Re: Dispute Notice – VNI West Project Assessment Conclusions Report

On 27 May 2023, AEMO Victoria Planning (AVP) and Transgrid published the Project Assessment Conclusions Report (PACR) for the Regulatory Investment Test for Transmission (RIT-T) process for the Victoria to New South Wales Interconnector West (VNI West).

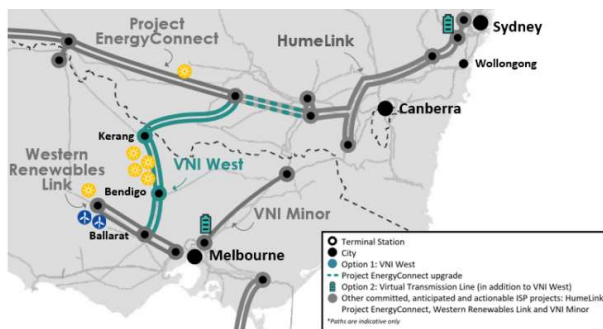
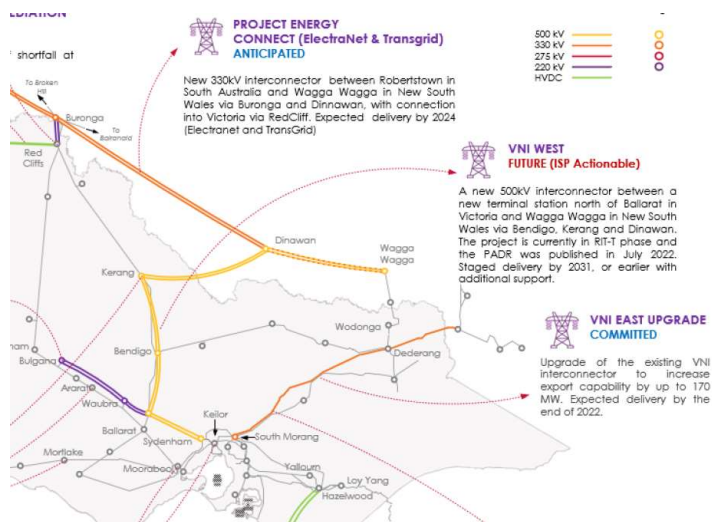
- At the time of the VNI West PADR (July 2022), just one month after the 2022 ISP, the cost of option 1, which is aligned to the ODP in the 2022 ISP, has risen to \$3,256m – a material change (increase) in cost of \$314m or 11%. At the time of this material change in cost, it would seem an ISP update was required by NER 5.22.15 but was not made. This is a non-compliance. For the route of option 1 see image below from the PADR:

iv. In support of (i)-(iii) see this image from the VNI West PACR.

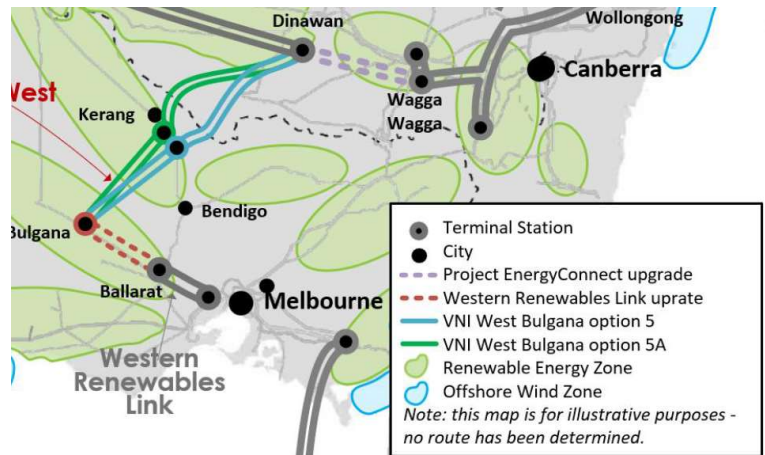
- Option 5A in the VNI West PACR records significant material changes to the ODP’s only ISP candidate option in the 2022 ISP:
 - Despite one less terminal station than the ODP, significantly more cost (now \$3,499m), a \$557m or 19% increase versus the ISP.

- Significantly different route change, the transmission line is connecting to the WRL ~110km to the west.
 - Significant Victorian interconnection changes, there is no longer a terminal station north of Ballarat, nor a terminal station nearby Bendigo, and so 2 of Victoria’s larger load centres are no longer serviced by the WRL or VNI West as had always been envisaged by the 2018, 2020 and 2022 ISPs.

- VNI West PACR notes at Section 3.2 that congestion issues with Bendigo will remain, they are not resolved by Option 5A.
 - In parallel to publishing the VNI West PACR, AEMO published in May 2023 its Draft Transmission Expansion Options Report (draft report for consultation for the 2024 ISP) wherein it proposes at s5.6.6 options to upgrade the transmission system around Bendigo at a cost between \$655m and \$1,061m.

- The switch from Option 1 to Option 5A poses a real risk of additional and unnecessary costs for consumers.

Figure 5 Relationship between the ISP, VAPR, and RIT-T in the national planning framework

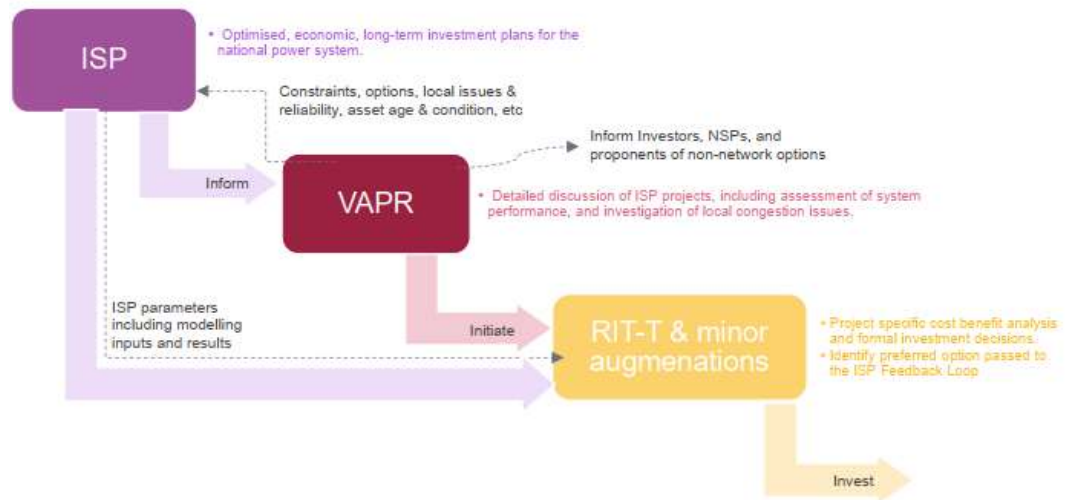
- AVP is an internal department of AEMO, within the one legal entity that is the transmission NSP for Victoria.
 - In its 2022 Victorian Annual Planning Report (VAPR), AEMO graphically illustrates the policy and regulatory context within which it operates, including the ISP feedback loop at the end. This graphic is on the following page:

- The feedback loop is defined in detail in the CBA Guidelines s3.5.3 with specific reference to NER 5.16A.5 and 5.22.15.
- Nothing in the NER nor CBA Guidelines exempts AVP, that is AEMO Ltd, from not having to seek ‘feedback loop’ confirmation – this statement in the VNI West PACR appears non-factual. Failure to undertake this ‘feedback loop’ task leaves the VNI West PACR with a preferred option that is not aligned to the ODP in the ISP.
